OFFICIAL STAR CLASS MEASUREMENT CERTIFICATE

Report from International Measurement Committee

Concerning : Star 3218
owner : Peter Viel
Builder: F. Wunder, Poertschach / Woerthersee
Kaernten Austria

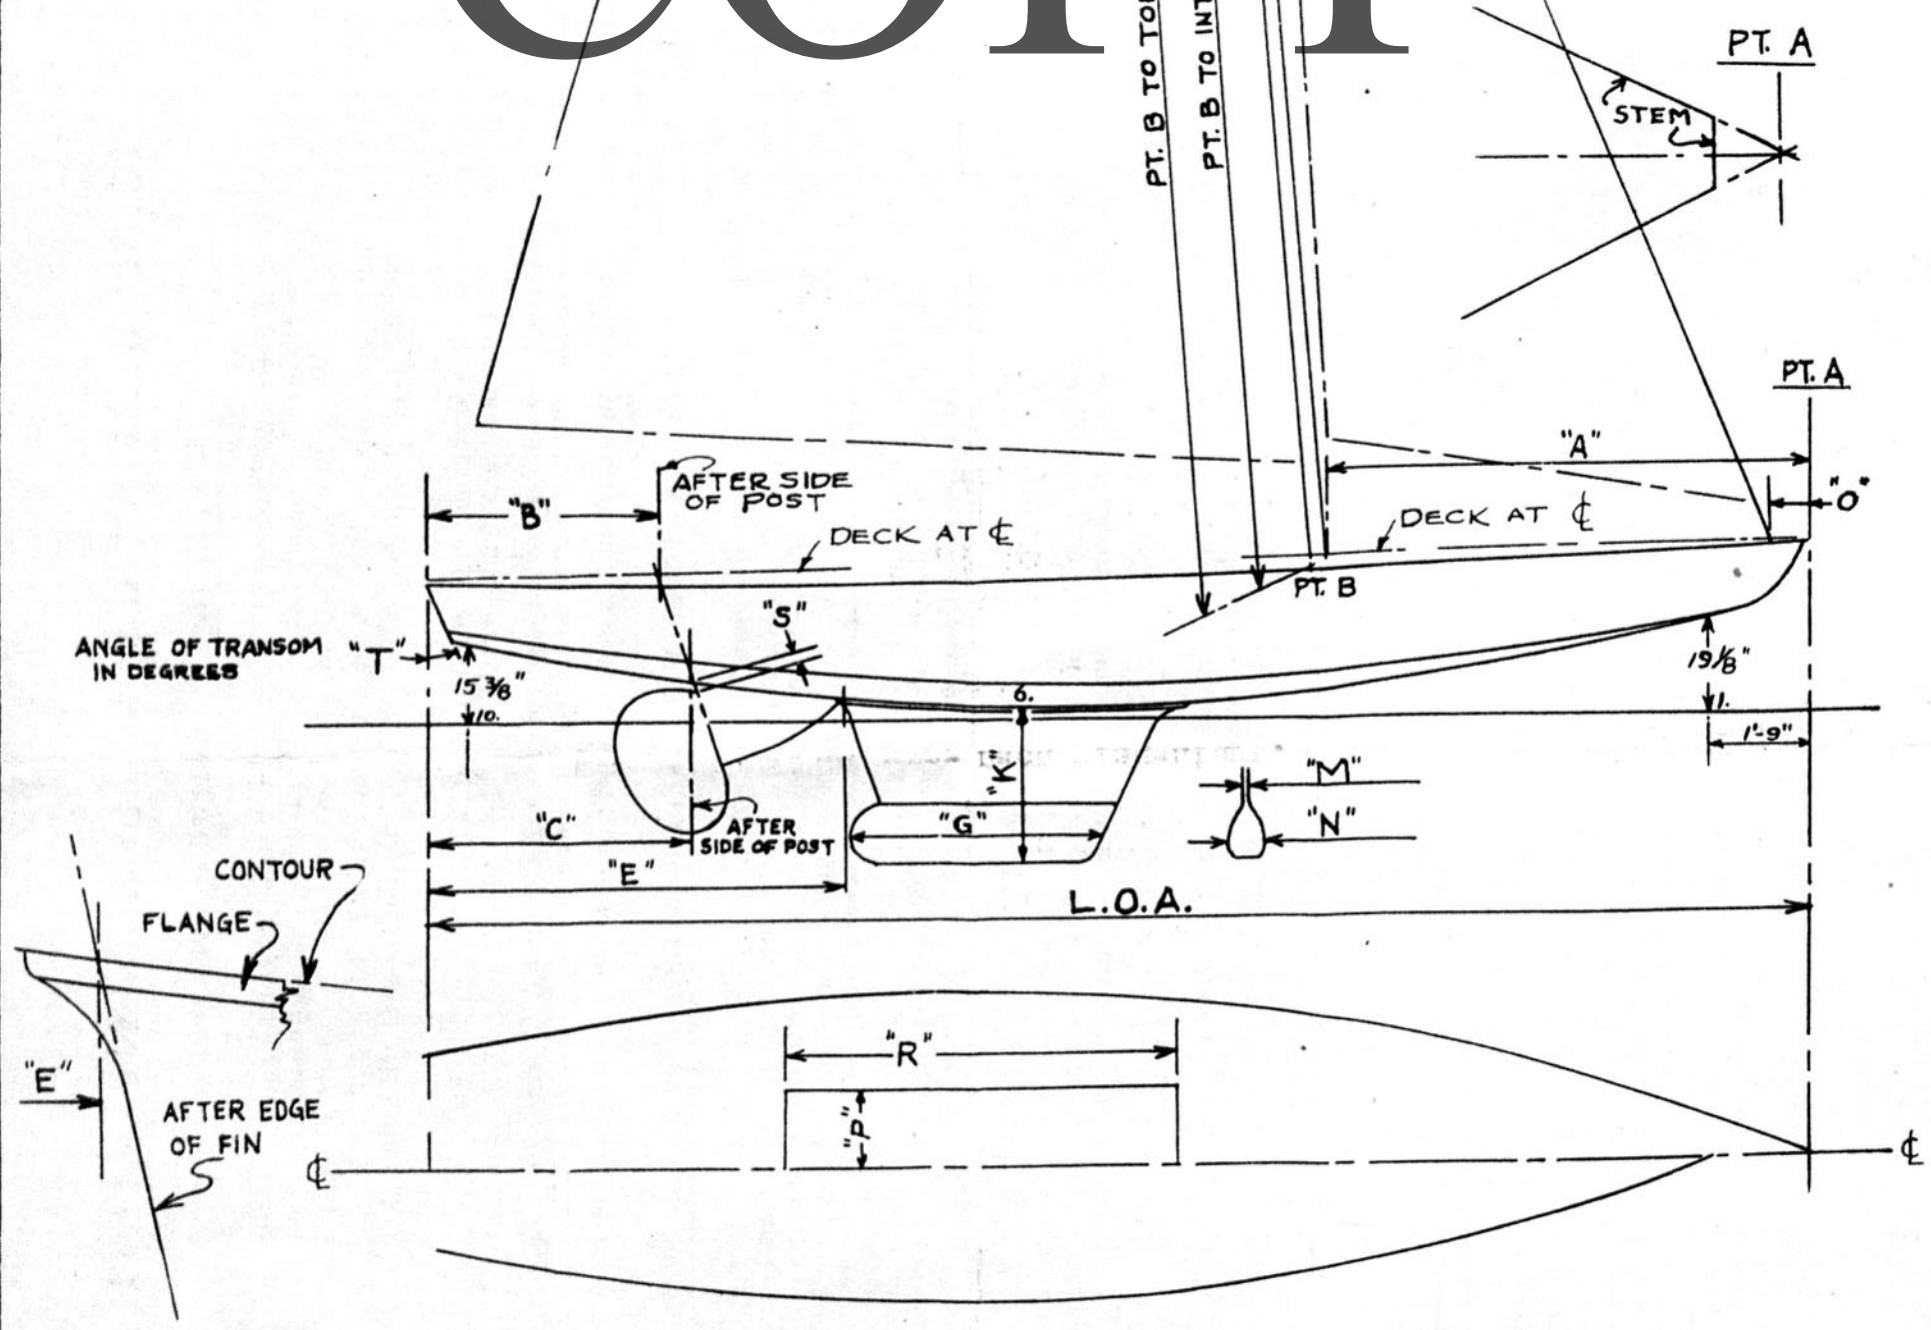
The Measurement Certificate for this boat cannot be approved due to the following points which do not comply with the Specifications:

- ☐ The points in question must be remeasured by a Certified Measurer and the results submitted to the Measurement Committee.
- ☒ The points in question must be altered to conform to the Specifications and then remeasured by a Certified Measurer and submitted to the Measurement Committee.

The points in question have been remeasured and I found the following results:

Chine height at Station 6 is 207 mm

Chine height at Station 8 is 293 mm

Dimension B has been a writhing error and shall be 1.193 m

Dimension N has been remeasured on 6 (six) places and I have now a middle-value of 20.8 mm
